Re: DSUP2020-10022, proposed drive-through retail at 5001 Eisenhower Ave

Attachment: Site Plan Excerpt

## Site Plan Excerpt (Sheet P-1101)

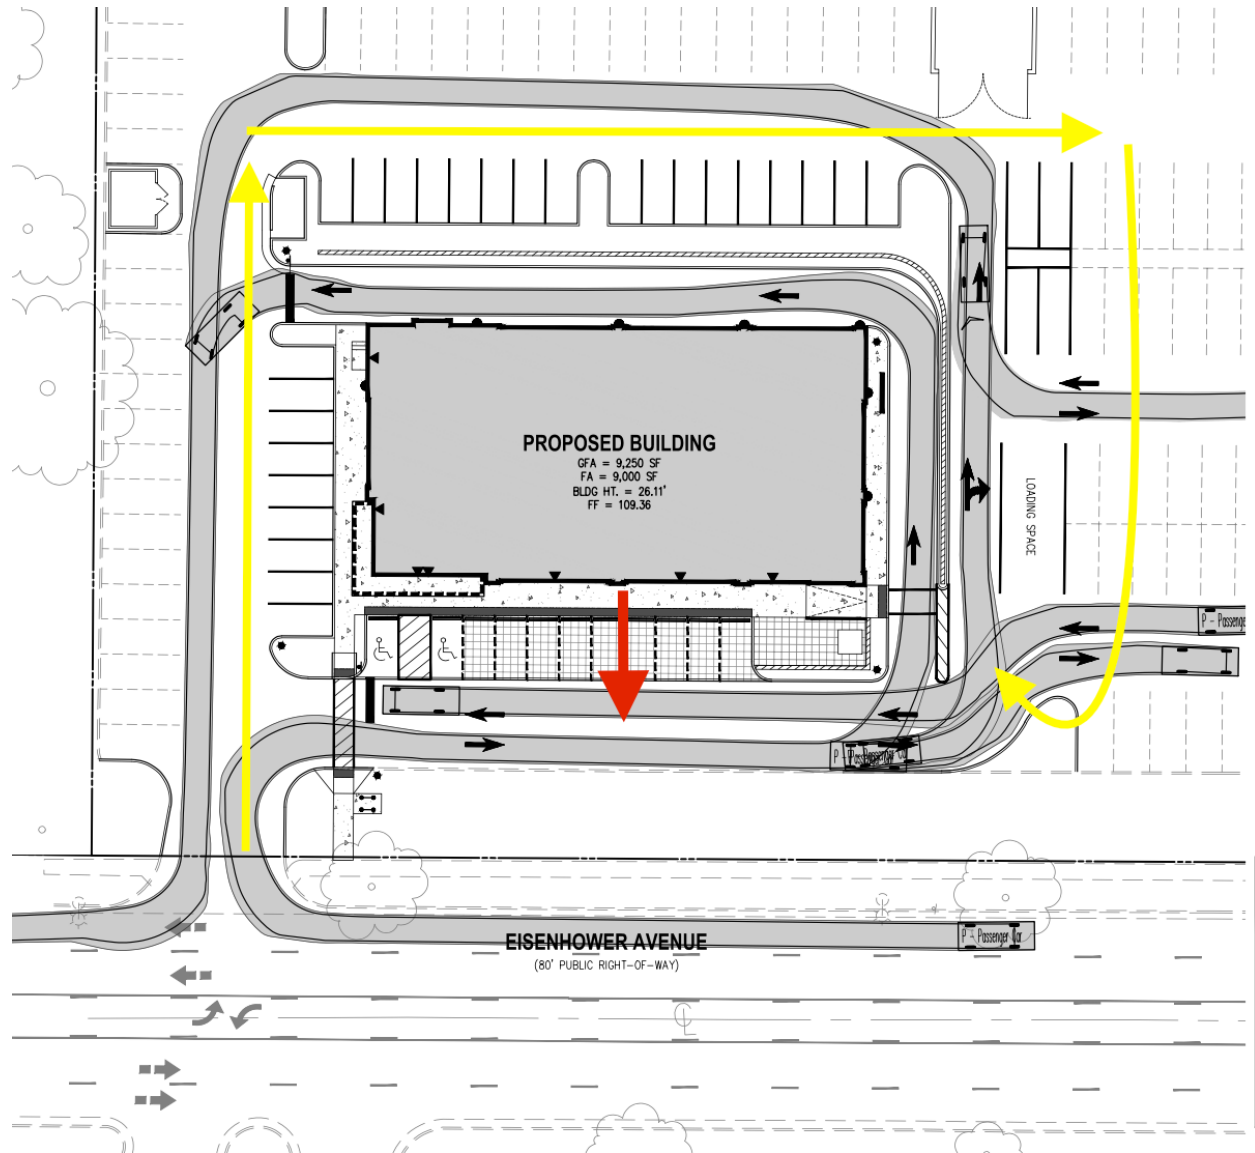
**Internal driveway and parking should not separate the building and patio from the street and sidewalk:**

In this particular case, the large site allows lots of flexibility to re-orient the drive-through lanes and parking so they do not separate the use from the street (see site plan excerpt, page 3). If this interim use is intended in part to support future occupancy of the Victor Center building as stated in the staff report, then the use needs to provide safe, convenient and attractive pedestrian access for building occupants (and also for the new townhome residents on the east side of the Victory Center property) as well as for neighborhood pedestrians and bicyclists in general. Currently, the site plan does not do this. With some refinements to the site plan, this use can provide needed retail while still signaling to the community that Eisenhower West is transforming into a more attractive, walkable, urban setting, not a suburban auto-oriented strip.

- As designed, use is isolated by driveways and parking from street, sidewalks, and public realm.
- Yellow lines added by me to show rough, indicative possible idea for alternate vehicular circulation that could allow building to front the street and retain drive-through.
- Red line indicates building and outdoor seating area shifted to front sidewalk.
